UNITED STATES
DEPARTMENT OF THE INTERIOR
BUREAU OF LAND MANAGEMENT

FORM APPROVED
OMB NO. 1004-0135
Expires: July 31, 2010**SUNDRY NOTICES AND REPORTS ON WELLS**
*Do not use this form for proposals to drill or to re-enter an abandoned well. Use form 3160-3 (APD) for such proposals.*5. Lease Serial No.
NMNM119271

☒ Oil Well ☐ Gas Well ☐ Other8. Well Name and No.
HARROUN RANCH FEDERAL COM 2H

BTA Oil Producers, LLC respectfully request the following changes to the Original APD, as approved:

13-5/8" 5,000 PSI BOP

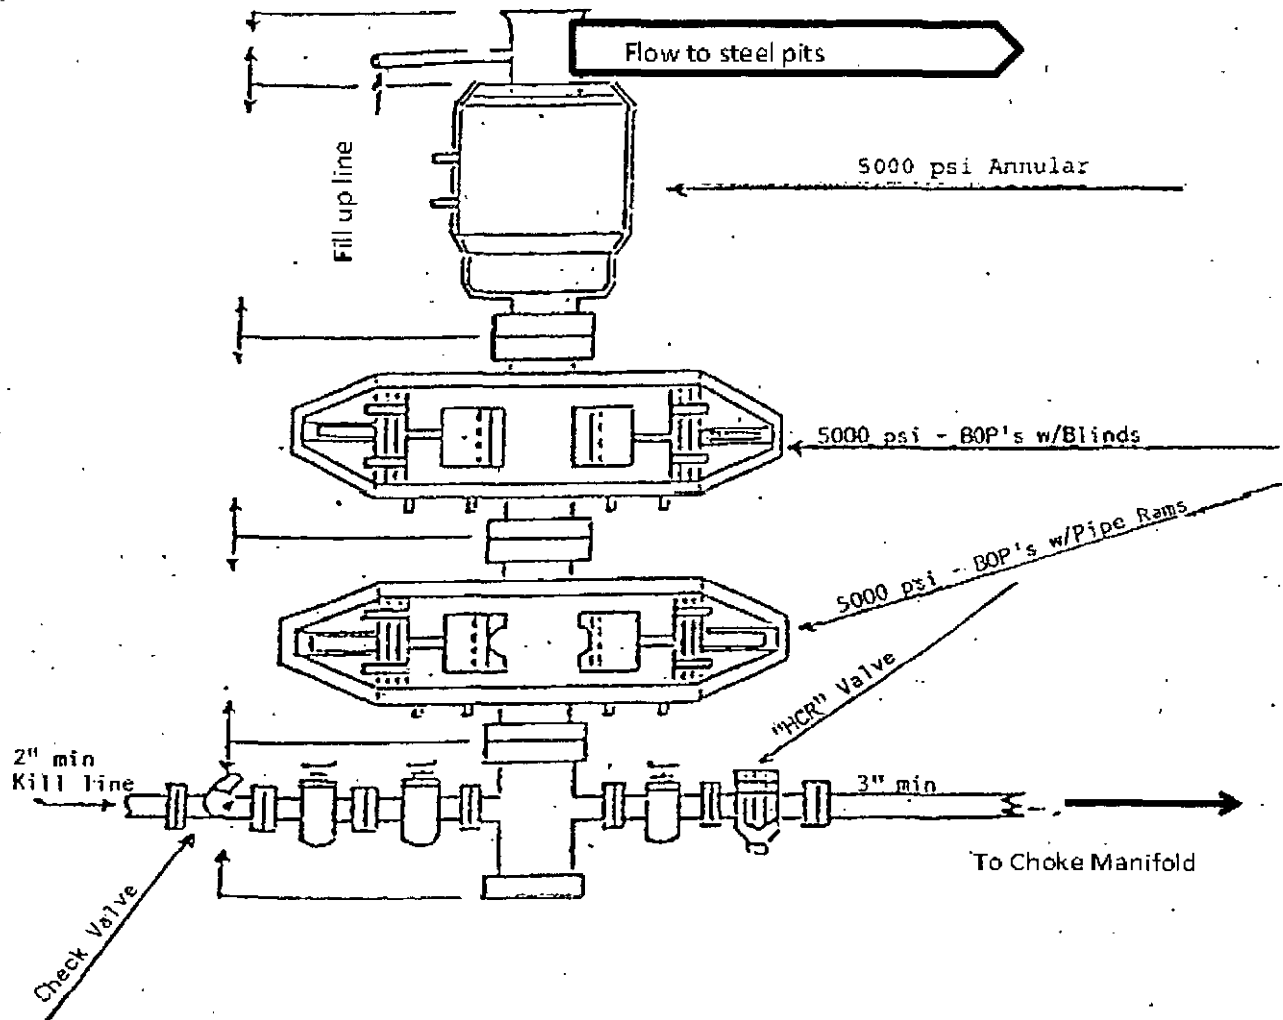
I submitted a sundry notice this morning and after routing the sundry I realized I forgot to attach the 5K BOP schematic. I'm not sure if there is any way I could do that on my side. I was wondering if you could attach this to the sundry referenced above? Please let me know if you have any questions or if you would like for me to send the attachment a different way. Thank you for your time in this matter.

It will be no problem for me to add the attachment. This is appropriate as is.
